**CITY OF TEMPE
DEVELOPMENT REVIEW COMMISSION**

Meeting Date: 05/10/2016
Agenda Item: 3

ACTION: Request for a Development Plan Review consisting of a new two-story, six unit multi-family development for 1037 FARMER (PL160053), located at 1037 South Farmer Avenue. The applicant is Form Third.

A001
SITE PLAN

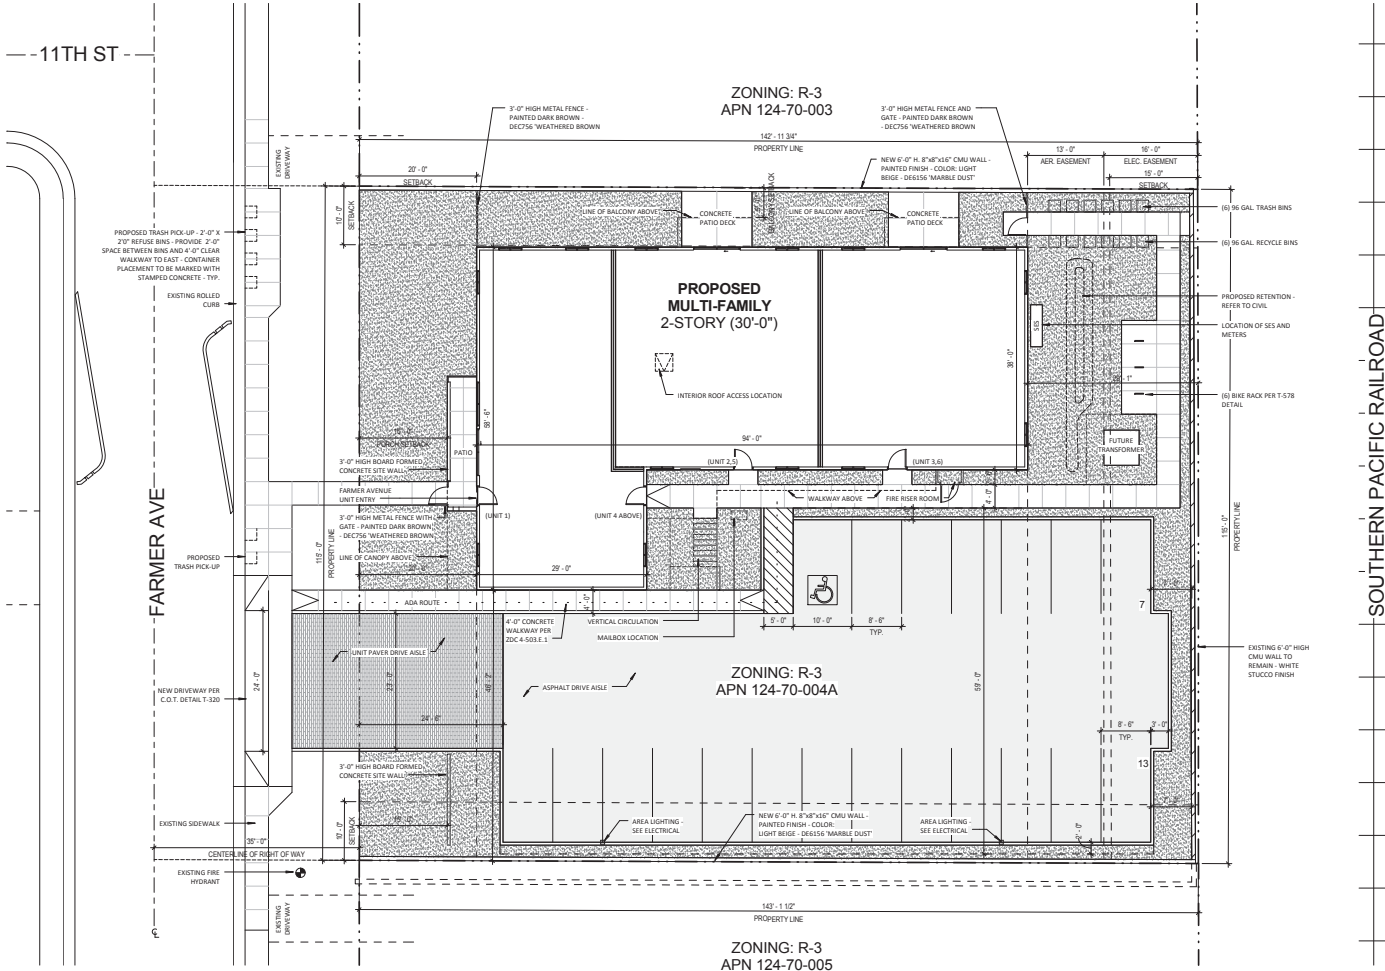
Vehicular access is provided by a single driveway on Farmer Avenue that leads to a 20-space surface parking lot. Bicycle parking and refuse bins are located adjacent to the east property line and accessed by a paved pathway. Trash and recycle bins are provided for each unit and will be rolled out to locations identified by the use of stamped concrete along Farmer Avenue. The public sidewalk adjacent to the refuse service areas will be increased in width to allow a minimum 4' wide clear path east of the bins.

High-voltage overhead utility lines exist along the east property line, and a 16' wide electrical and 13' wide aerial easement run the length of the property below the lines. This prevents the building from being located at the 15' rear setback that is normally permitted in the zoning district. The development contains six apartment units within a single building that is two-stories, 29' in height. Each unit has separate exterior access. All units have covered patios accessed through the living

Six-foot high block walls are proposed along the north and south property lines, and the existing 6' wall along the east property line will remain. The plan notes that the new walls will be painted, and staff has included a condition that requires the new walls to be constructed of integrally colored block instead of painted.

2. Provide a pathway to the service entrance section (SES) on the east end of the building. Pathway may consist of concrete, stabilized granite, or unit pavers.

3. The new 6' high CMU walls along the north and south property line shall be constructed of integral colored block and shall not be painted.
4. Provide locations for both refuse and recycling collection on-site and provide service pick-up along Farmer Avenue as identified on the site plan.

5. Provide upgraded paving at the driveway consisting of integral colored unit paving, as identified on the site plan. Extend this paving in the driveway from the right-of-way line to 20'-0" on site and from curb to curb at the drive edges. From sidewalk to right-of-way line, extend concrete paving to match sidewalk.

1 SOUTH ELEVATION
18' = 1'-0"

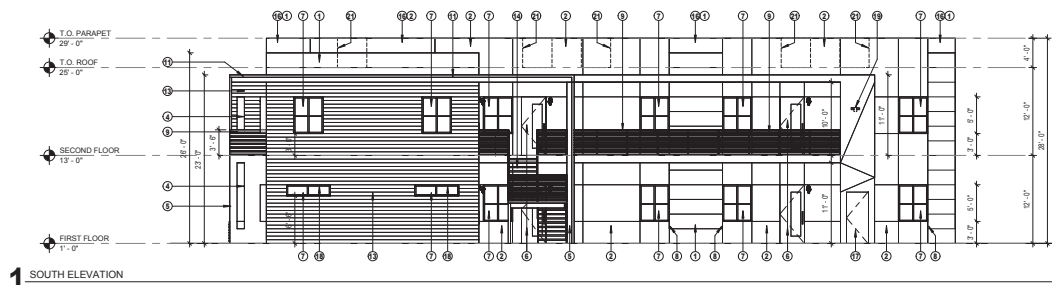
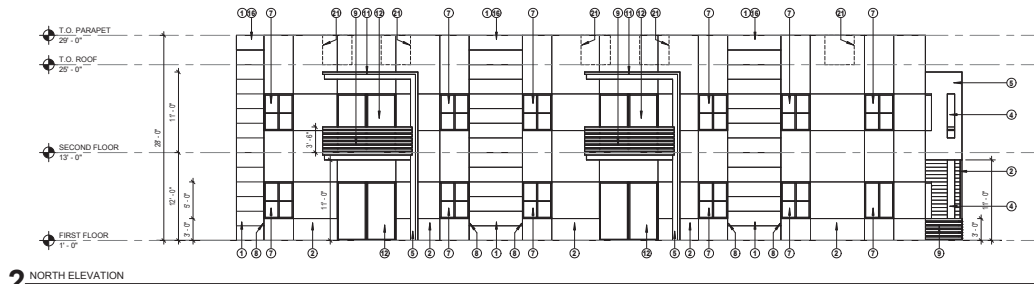
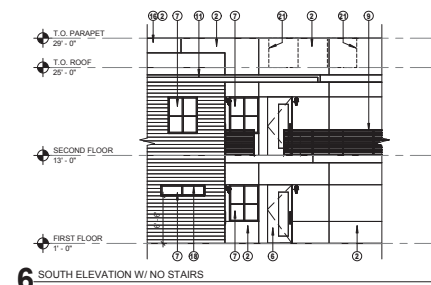
Several of the windows on the west and south elevations have 12" deep L-shaped canopies for shade. A condition is included to require canopies on the two second-floor windows on the south elevation that are directly above the two horizontal windows. These canopies would shade the top and left side of the windows.

Wall-mounted light fixtures on the west and south elevations that are intended to illuminate the ground below are shown mounted at approximately 18.5' high. In order to minimize undesirable light and glare into adjoining properties and light pollution into the nighttime sky, a condition is included to reduce the height of these three lights to a maximum of 12'.

10. All glass used in main entry doors and sliding glass patio doors shall be insulated and laminated.
 11. Add 12" deep L-shaped canopies to the two second-story windows on the south elevation located directly above the horizontal windows. The canopies shall be on the top and left sides of the windows.

12. Reduce the height of the two wall mounted lights on the west elevation and the one wall mounted light above the fire riser room on the south elevation to a maximum of 12'.
13. Provide secure roof access from the interior of the building. Do not expose roof access to public view.
14. Conceal roof drainage system within the interior of the building.
15. Incorporate lighting, address signs, and incidental equipment attachments (alarm klaxons, security cameras, etc.) where exposed into the design of the building elevations. Exposed conduit, piping, or related materials is not permitted.
